ORDINANCE NO. **8561**

AN ORDINANCE concurring with the recommendation of the Zoning and Subdivision Examiner to approve subject to conditions (modified) the Preliminary Plat of GLENCARIN EAST, designated Building and Land Development File No. 188-21.

ADDENDUM REPORT TO THE ZONING AND SUBDIVISION EXAMINER
MAY 11, 1988 - PUBLIC HEARING

PROPOSED PLAT OF GLENCARIN EAST

Copy of the May 2, 1986 Revised Plat Design

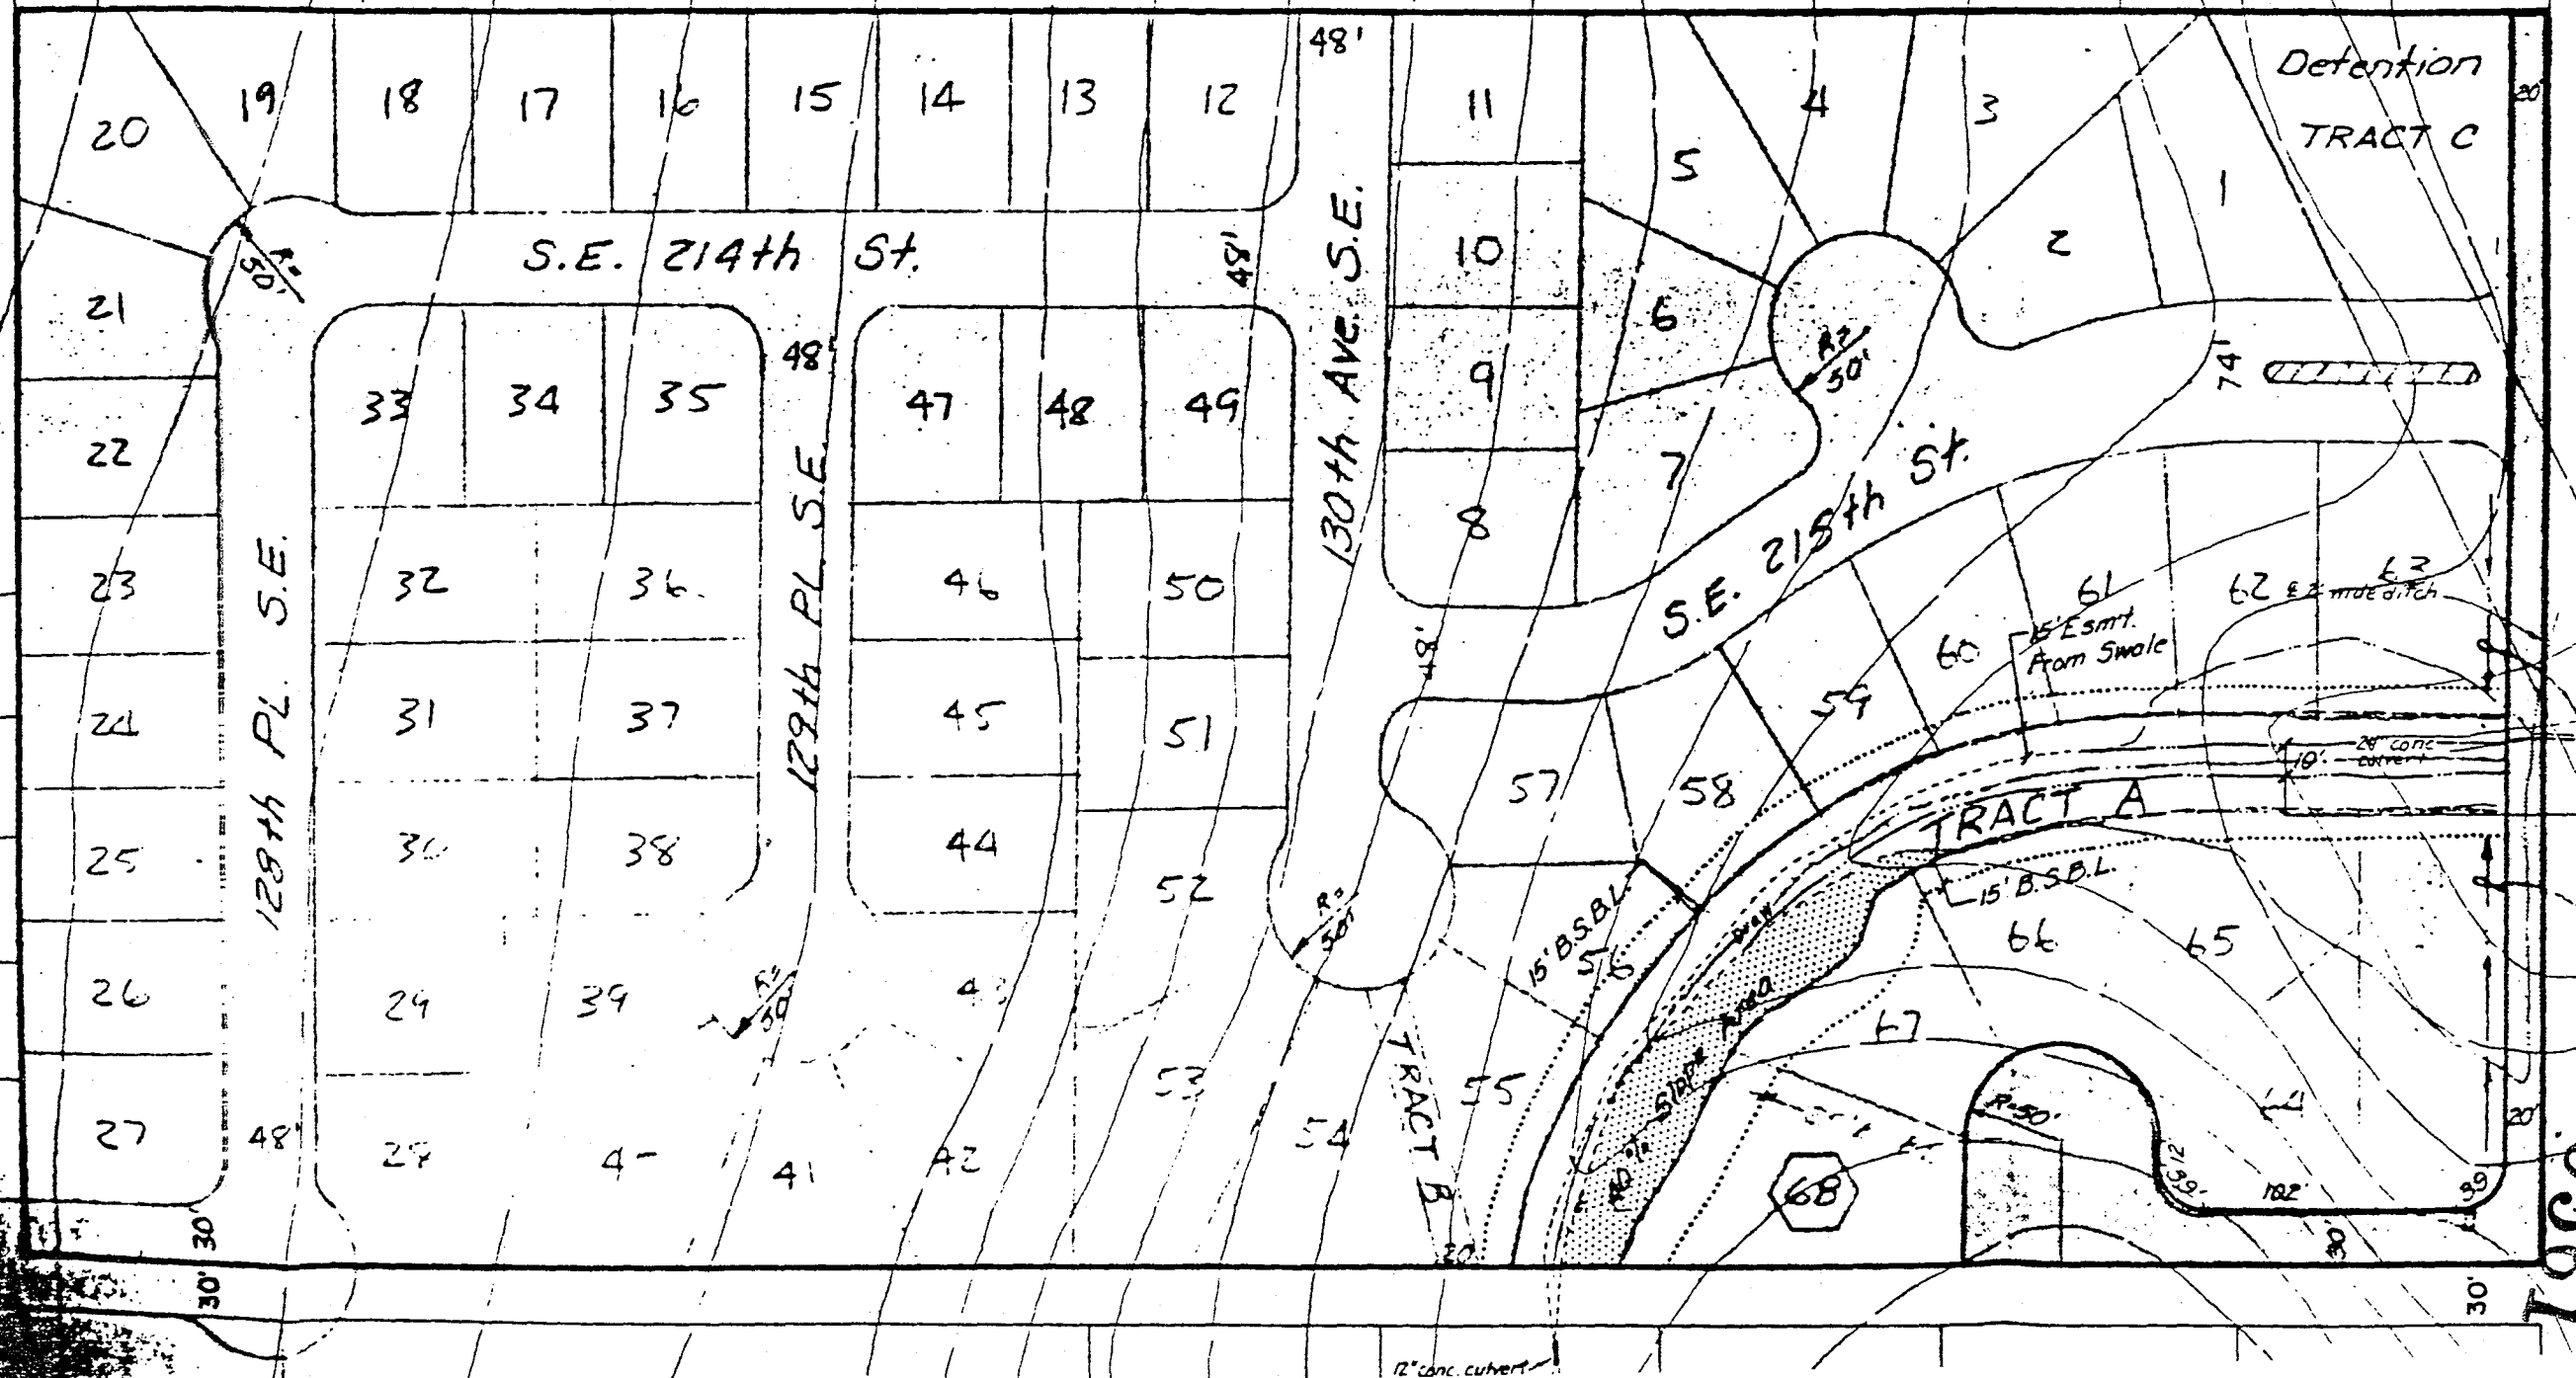
Subsequently, on March 21, 1988 the Examiner received a letter from the applicant's engineer concerning the need to modify Condition 26 and 27 of the Examiner's Report and Recommendation to the County Council. This request was based on the applicant's inability to obtain the right-of-way needed to construct Southeast 216th Street as a full width street and some topographic constraints which would make it difficult to construct. The applicant felt that with these constraints it would again require the plat to be redesigned and he would submit several design alternatives to the STC. On April 14, 1988 the applicant's engineer met with the STC to discuss the merits of several revised plat designs. April 28, 1988, the STC again met with the applicant's engineer to review a more detailed plat design and concluded that the design which moved the primary access from Southeast 216th Road to the northeastern portion of the site was accepted by the Committee. The STC then advised the applicant to present this design to the citizen group representing the neighborhood concerns. On April 28, 1988, this group supported the revised plat design approved by the STC (see May 2, 1988 Revised plat design).

The Subdivision Technical Committee reviewed the applicant's plat redesign and determined that the revised plat adequately addressed the primary issue raised by the Glencarin neighborhood group concerning the use of the Glencarin neighborhood as a by-pass route to 116th Avenue Southeast and encouraged the use of the existing arterials and neighborhood collector street. Therefore, the STC has no objection to the plat redesign provided that the applicant complied with the conditions of Final Plat Approval.

It is recommended that the subject subdivision, revised and received May 2, 1988, be granted preliminary approval subject to the following conditions of final approval:
